City of Phoenix

ADDENDUM A **Staff Report: Z-77-21-7** April 29, 2022

Estrella <u>Village Planning Committee</u>	April 19, 2022
Meeting Date:	
<u>Planning Commission</u> Hearing Date:	May 5, 2022
Request From:	<u>PUD</u> (Planned Unit Development District) (36.69 acres)
Request To:	<u>R1-10</u> (Single-Family Residence District) (36.69 acres)
Proposed Use:	Single-family residential
Location:	Southeast corner of 75th Avenue and Broadway Road
Owner:	DNZ Holdings, LLC
Applicant:	Lennar
Representative:	William Lally, Tiffany & Bosco, PA
Staff Recommendation:	Approval, subject to stipulations

BAILEY PARK • CONCEPTUAL LOTTING PLAN

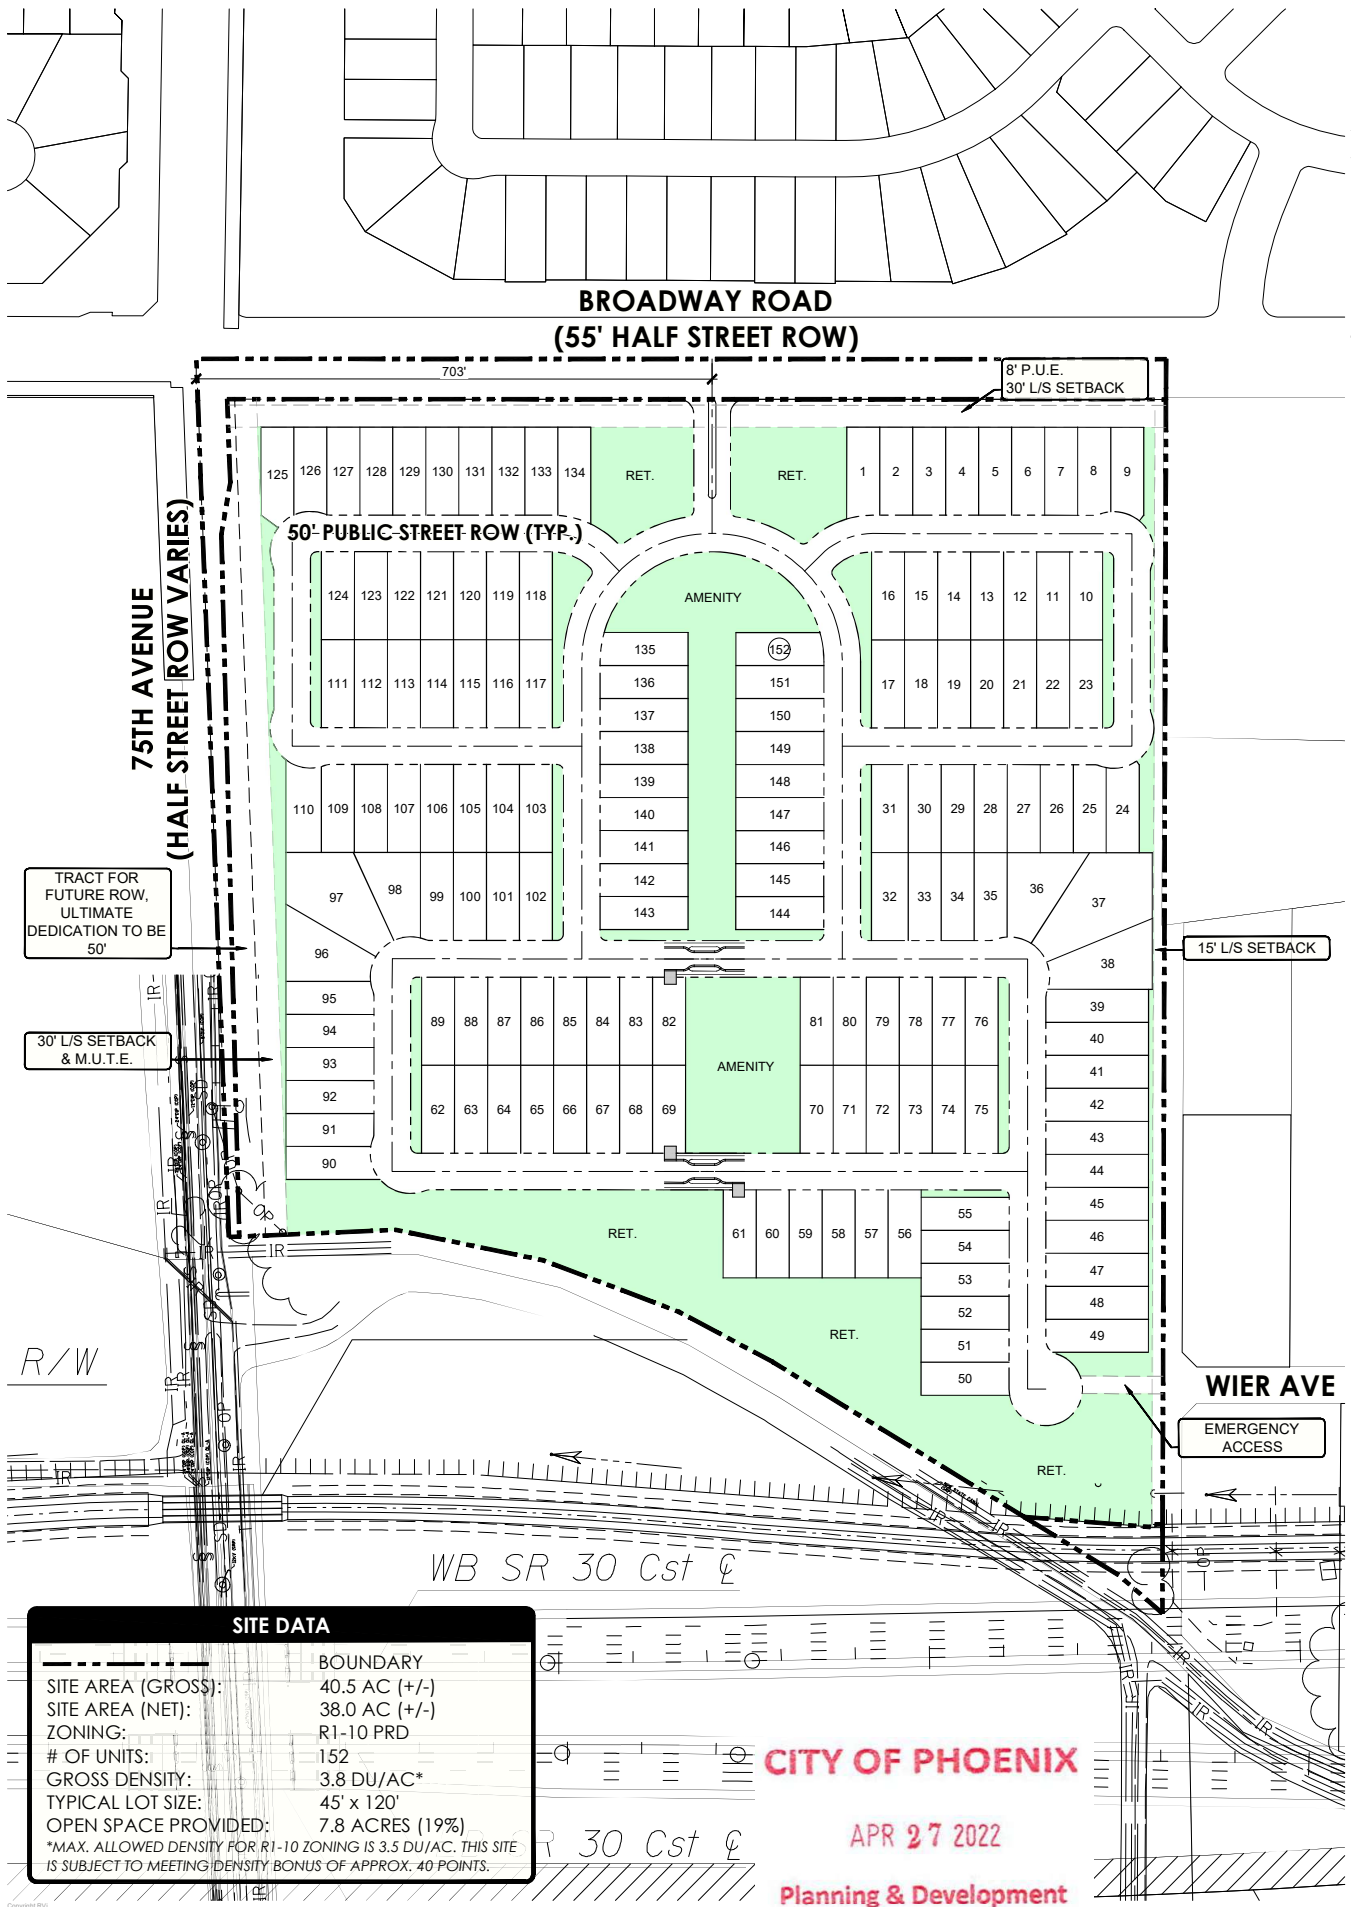
The Estrella Village Planning Committee heard this rezoning request on April 19, 2022 and voted (6-0) to recommend approval per the staff recommendation. Following the April 19, 2022 meeting, the applicant provided an updated site plan, attached to this report, depicting a decrease in the number of lots from 159 to 152 on the subject site. Furthermore, the updated site plan depicts a change in the lot layout and an increase in the landscape setback width along the 75th Avenue alignment consistent with Stipulation No. 3.

Staff does not recommend general conformance to the updated site plan as density bonus points are being sought by the applicant following the rezoning process to achieve the requested density. The subject site is also subject to other requirements from the Subdivision Ordinance and street access approval from Maricopa County Department of Transportation for any county-controlled streets.

Due to these changes, staff recommends modifying **Stipulation No. 1** regarding a minimum 140-foot lot depth applicable to lots backing onto the eastern perimeter of the site.

1. Lots ~~within 30 feet of~~ WITH A REAR LOT LINE ALONG the eastern perimeter ~~property line~~ OF THE SITE shall be a minimum of 140 feet in depth.
2. A minimum 15-foot-wide landscape setback shall be provided along the eastern perimeter property line (s), as approved by the Planning and Development Department.
